DSOX3024A-03

S E R V I C E N O T E

DSOX3024A – Oscilloscope, Mixed Signal, 4 Channel,
200MHz

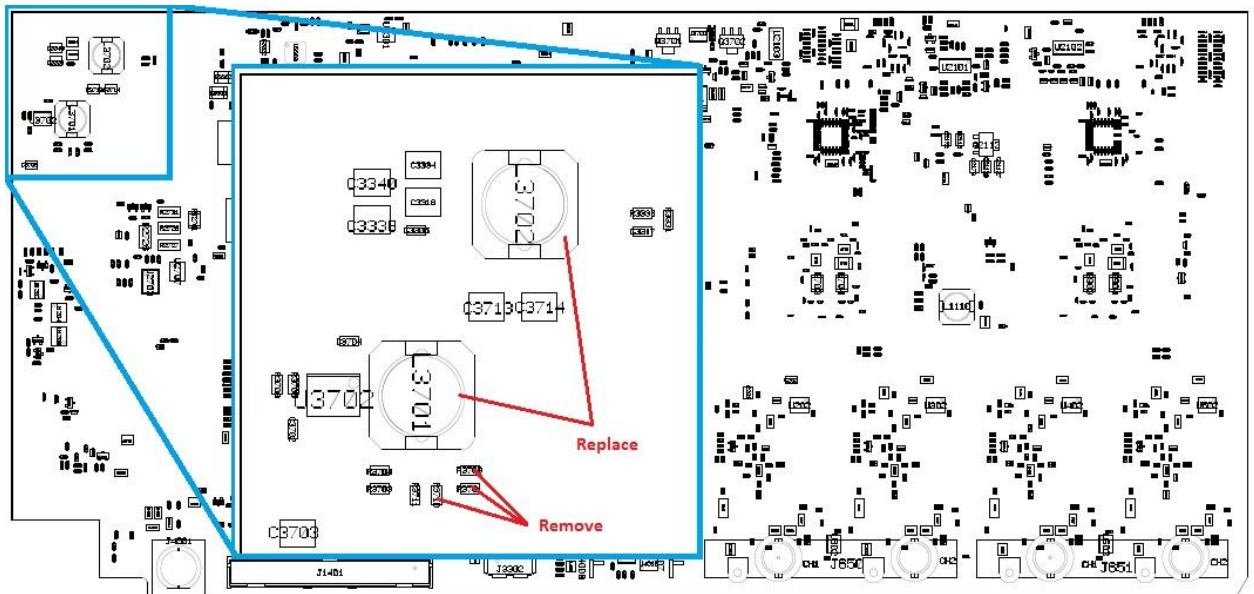
With the oscilloscope power turned on and while under normal operation, the unit emits a hissing noise.

2. As the picture indicates, remove the three resistors (0699-7209, 1 Ohm) located at R3701, R3709, and R3710. They are not to be replaced.
3. Remove as well the two inductors (9140-6474, 100uH) located at L3701 and L3702 and replace them with inductors with part number 9140-6151 (68 uH).
4. Re-assemble to the point where the unit could be powered up to verify that the hissing is indeed gone. If the hissing is not gone, please, check modifications.
5. When the hissing is gone, put oscilloscope back together.
